**SUBDIVISION REVIEW SHEET****CASE NO.:** C8-2018-0039.0A**PC DATE:** February 12, 2019**SUBDIVISION NAME:** Stobaugh Resubdivision**AREA:** 1.16 acres**LOTS:** 6**APPLICANT:** Joseph Mueller**AGENT:** Civiltude, LLC (Eyad Kasemi)**ADDRESS OF SUBDIVISION:** 1200 Stobaugh**GRIDS:** MK29**COUNTY:** Travis**WATERSHED:** Waller Creek**JURISDICTION:** Full Purpose**EXISTING ZONING:** SF-3-NP**DISTRICT:** 7**LAND USE:** Residential**NEIGHBORHOOD PLAN:** Crestview**SIDEWALKS:** Sidewalks will be constructed along Stobaugh Street

**STOBAUGH RESUBDIVISION, A RESUBDIVISION OF  
LOTS 12, 13 AND A PORTION OF LOT 11, BLOCK E  
OF THE NORTHGATE ADDITION  
City of Austin, Travis County, Texas**

Re: Letter of Submittal and Sufficient Existing Service  
Stobaugh Subdivision Service Extension Request for Water (SER-4263)  
1112, 1200, and 1202 Stobaugh Street, Austin, Texas, 78757

## TAP CONCEPT PLAN DRIVEWAY & UTILITY PLAN

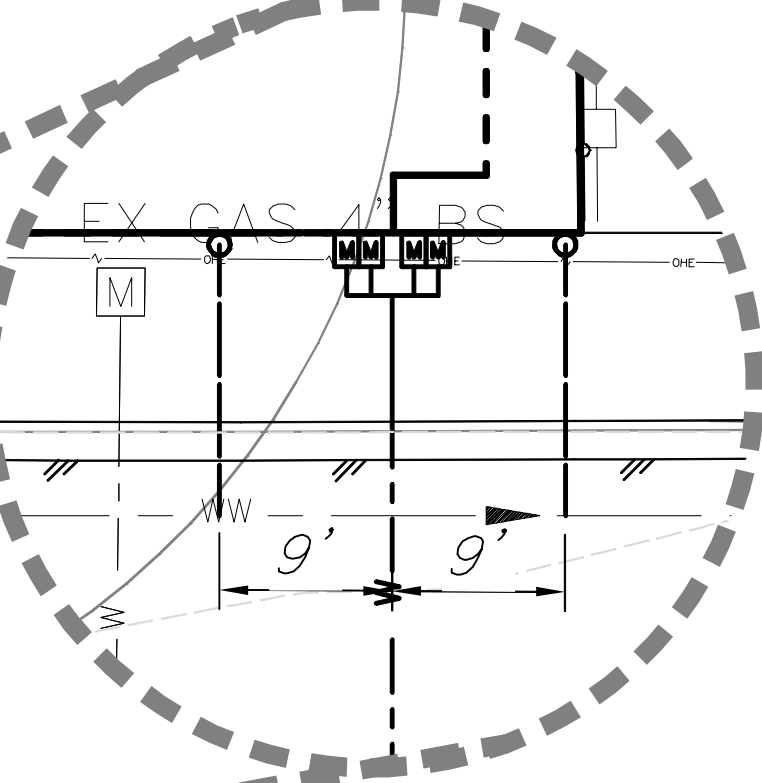
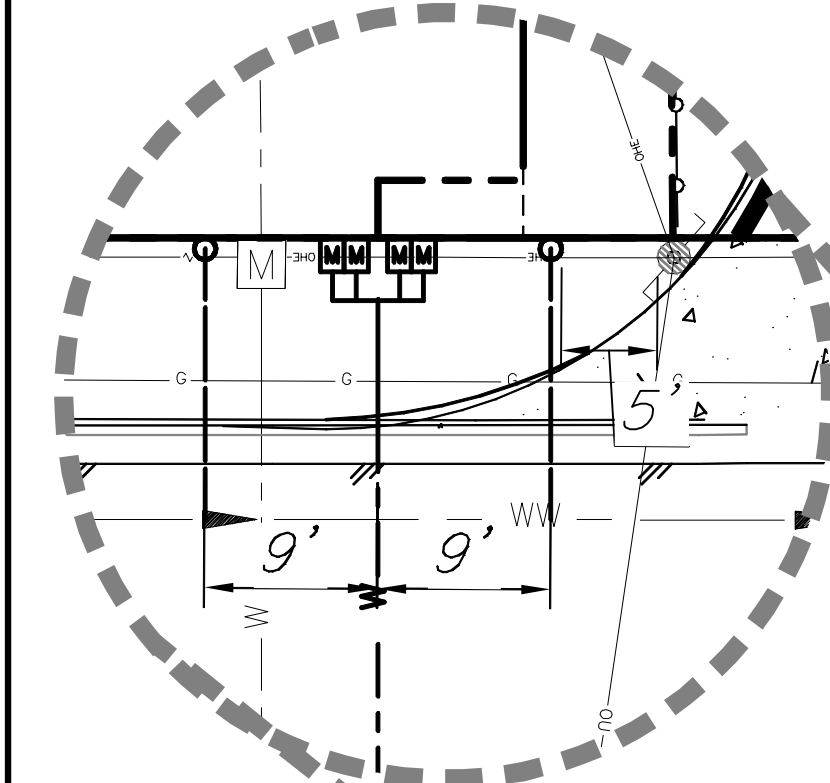
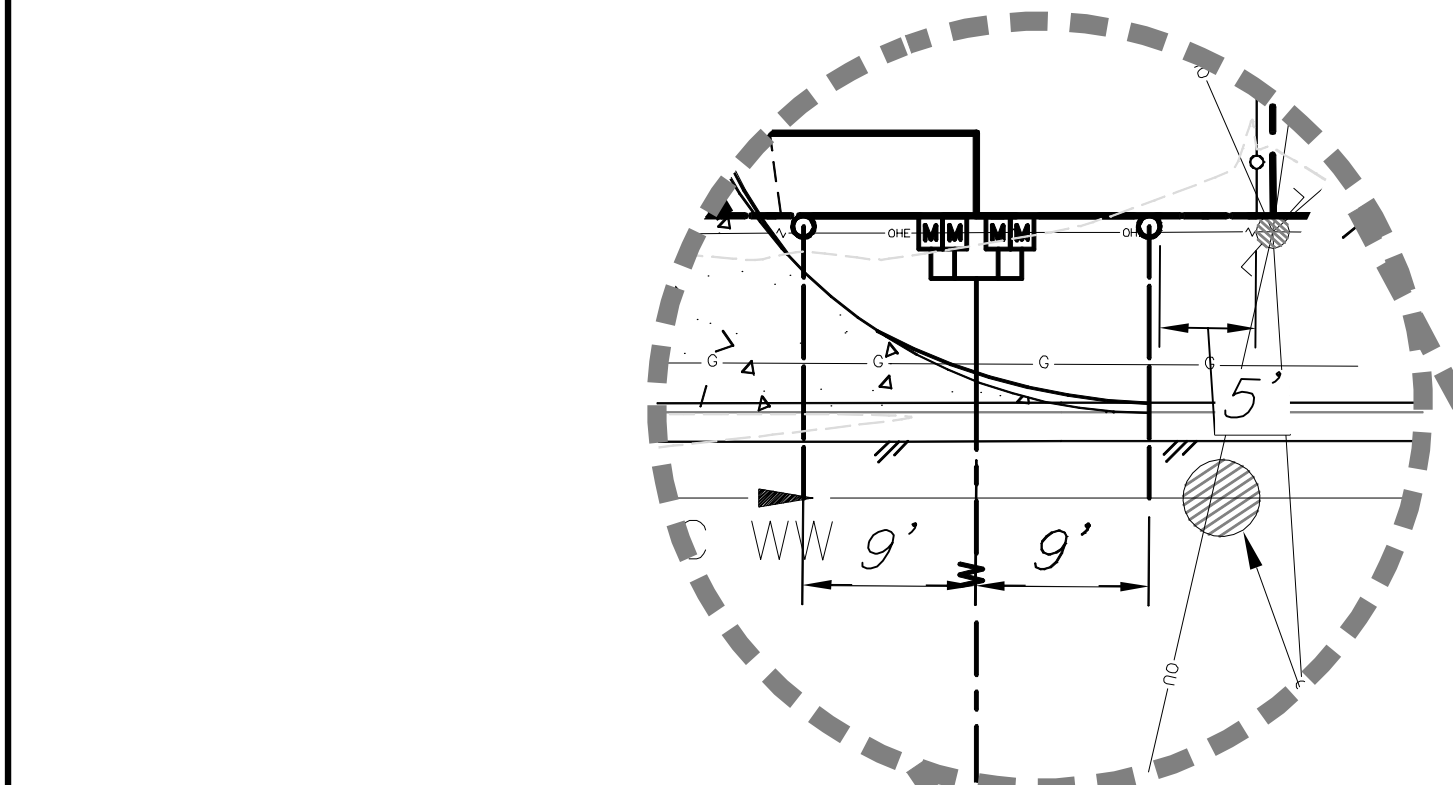
**AUSTIN WATER REVIEWED**  
DATE: 11/21/2018 EXPIRATION DATE: 11/21/2021  
Austin Water Representative: KENNETH KUBA

Subdivision review only - An engineered tap plan must be submitted to Austin Water for review and approval prior to obtaining a building permit
